PROJECT:	Beaver Bend Park and Trail Reconstruction	PAGE:	1 of 3
		DATE:	November 17, 2022
		PROJECT NO.:	982-153
OWNER:	Village of Warfield	DISTRIBUTION:	
		Owner	(X)
		Village Website	(X)
ISSUED BY:	Nathan Lee, P.Eng.	Pre-tender mtg.	
	TRUE Consulting	attendees	(X)

TO ALL TENDERERS OF RECORD

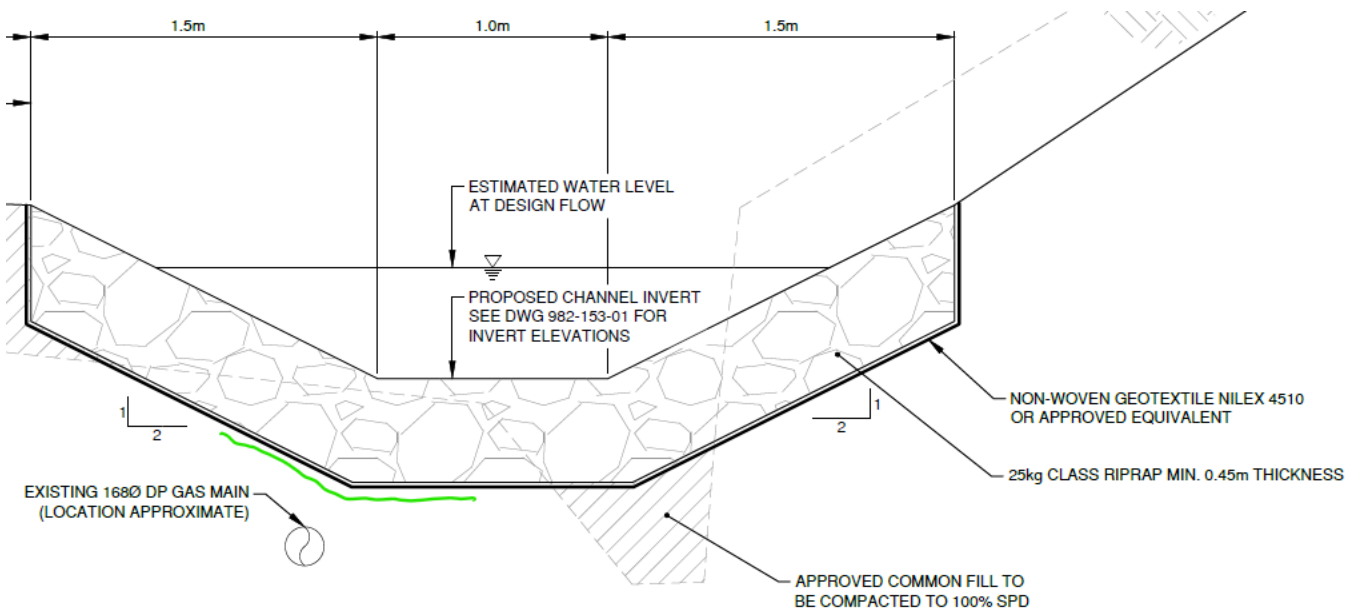
Q: Does the rubber matting (Item 3.8) get wrapped around the gas main?

A: The rubber matting, if required, can be placed in the bed of the channel underneath the geotextile fabric, generally as depicted in green, below.
